PLANNING APPLICATION FORM

Location / Address: 112 Flinders Street Beauty Point TAS 7270

PA2026167 - AMC Seamanship Centre Workshop Refurbishment - 112 Flinders Street, Beauty Point
Response to request for further information

Figure 1 Proposed site plan (Source: GHD)

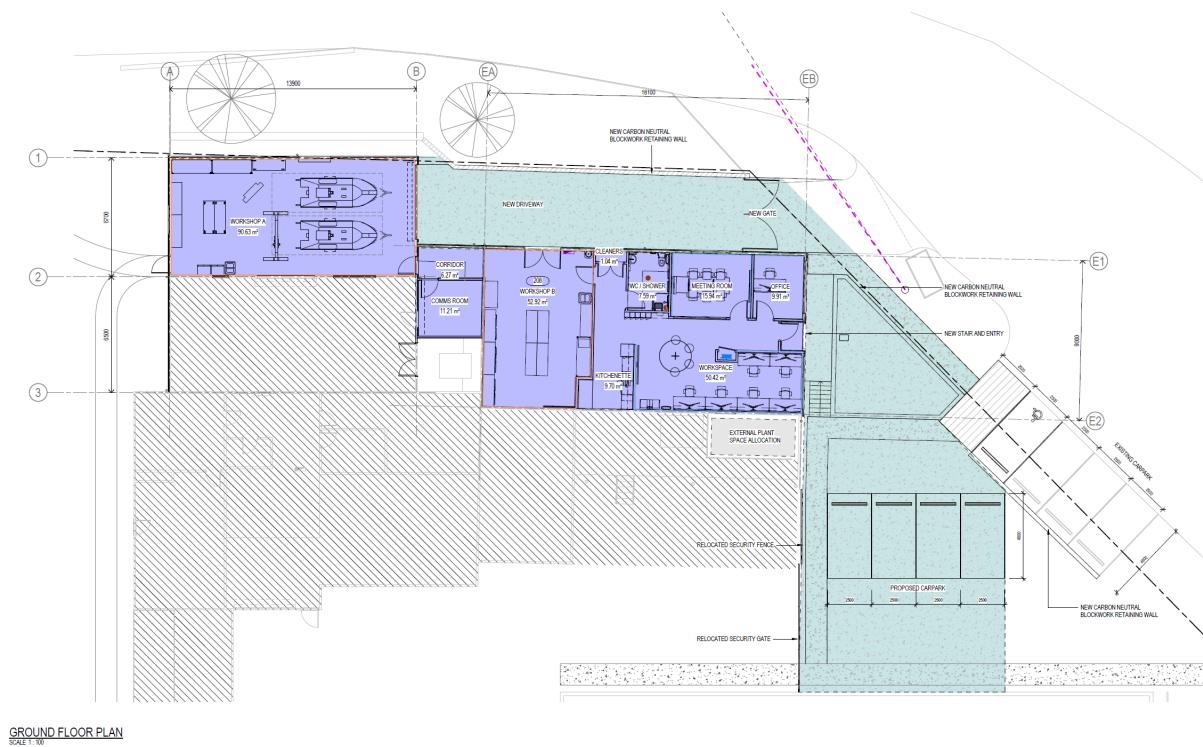
RFI no.	Information requested	Response
1	Please provide a site plan showing the whole site, and a brief description of other buildings and uses on the land. <i>Advice: it may be appropriate to explain how the site and the Crown land to the east operate together.</i>	A site plan has been prepared and is attached. The rest of the site is used for tertiary education as part of AMC. The Crown land to the east of the site is leased to AMC (Agreement ID 130042).
2	Regarding the proposed logo signage, please provide dimensions and materials for both to ensure complete assessment against Clause C1 Signs Code.	Dimensions have been included in the revised plans. The planning report has been revised to include an assessment against the Signs Code.
3	It is not suitable to count parking spaces partially in the road reserve as "on site parking". Regarding the assessment of C2.5.1, please indicate how many tertiary students would be expected on site to enable complete assessment of parking requirements (this includes on the other parts of the same site as indicated in the site plan requested under #1). If there are no tertiary students, please explain how to the proposed use remains Education and	We acknowledge Council's position that the parking spaces partially within the road reserve are not counted as onsite car parking spaces. The proposed use remains Educational and Occasional Care and a further explanation is included within this letter. Tertiary students participating in placement, industry engagement and training activities will be users of the site. The number of tertiary students

RFI no.	Information requested	Response
	Occasional Care, rather than Research and Development?	using the site will vary throughout the year. Notwithstanding, students will consistently use the site as part of the AMC course requirements and will primarily be transported to and from the site by coach from the AMC Newnham campus and are not anticipated to generate additional parking demand. The assessment against C2.5.1 in the planning report has been revised to reflect the above.
4	The planning report assessment of bike parking need (C2.5.2) is not supported. In an urban location such as Beauty Point town, it is appropriate to improve bicycle facilities and encourage sustainable transport options wherever possible. Please update the site plan to show two bike parking spaces (one hoop) or more as required by the number of tertiary students not previously accounted for.	A bicycle hoop has been added to the plans to reflect Council's position. Students will primarily be transported to and from the site by coach from the AMC Newnham campus and are not anticipated to generate parking demand. The assessment against C2.5.2 in the planning report has been revised to reflect the above.
